**Operator:** 8 North

**Location Name:** SHABLE PC GK 19-99HZ

**Loc ID:** 416924

**Inspection:** 684905120

**Exhibit D**

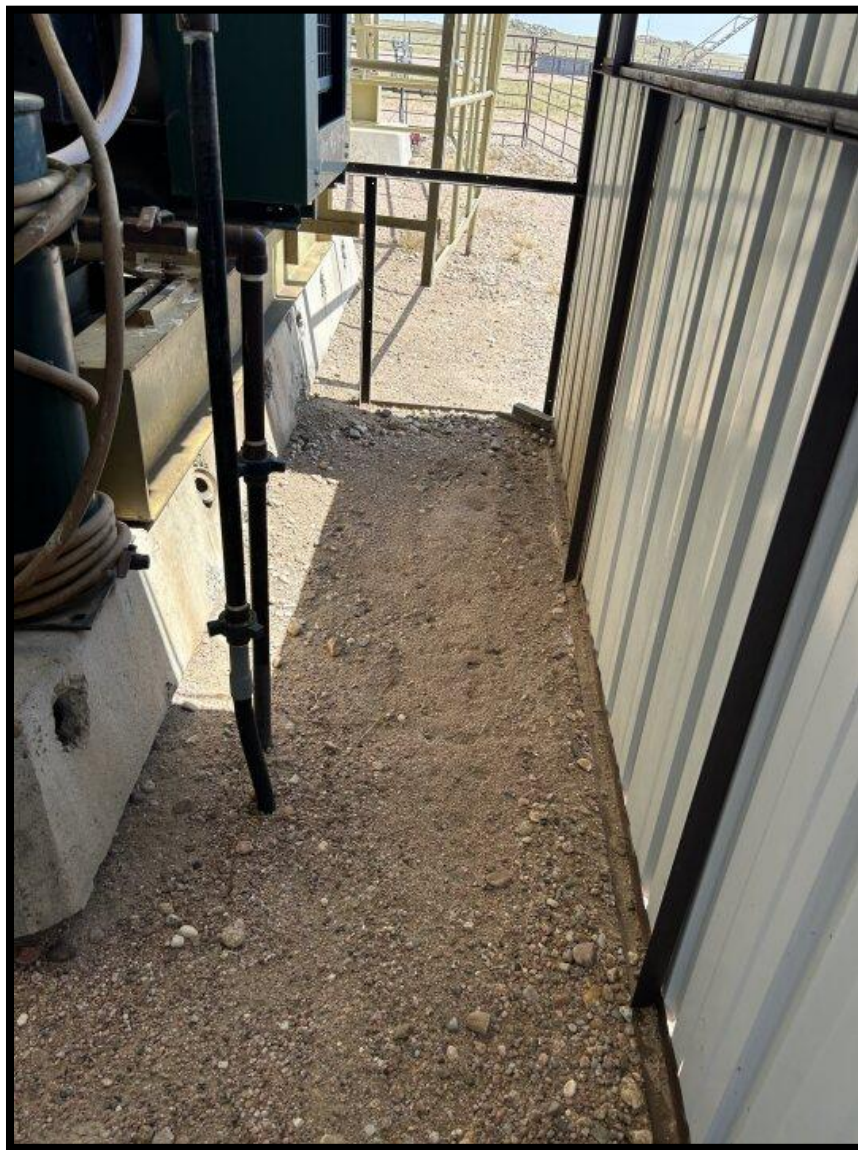
**CA:** Stained soil at wellhead, around H<sub>2</sub>S scavenger containment, around engine. Corrective Action: Comply with rule 603.f

**CA Resolution:** Operator has provided photo evidence showing that the stained soil at the affected areas has been removed to comply with the 600 series.
